Service Information Letter

Letter No. A-129

Overheat Limit Switch Replacement - P/N ()07D29 for Janitrol Aircraft Cabin Heaters

Figure 1 - New switch detail

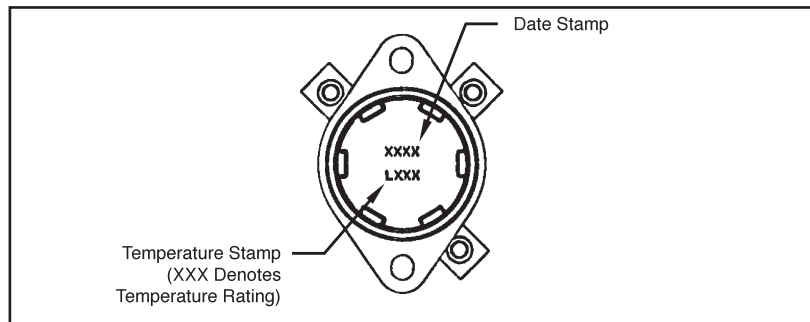
2. The new switch is shown from the sensor side as seen in Figure 1. This side shows the date code stamp and temperature rating stamp. *See Table 1*
3. The new switch as shown in Figure 2 will use the same gasket , hardware and hardware torque as the original. However depending on the heater wiring, the connections may need to be adjusted to accommodate different length or geometry. Be sure to record and mark all wire positions prior to removing to ease reinstallation. *Never use an inline splice, always trace the wire to its source or nearest terminal connector and replace the entire wire using equivalent type and size wire and terminals.*

Figure 3 - Existing (old) switch style

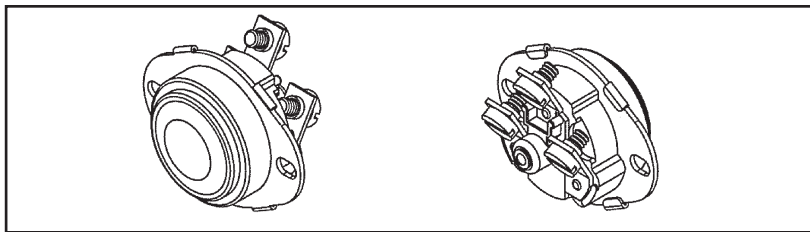
4. For comparison, see the existing style switch shown in Figure 3.
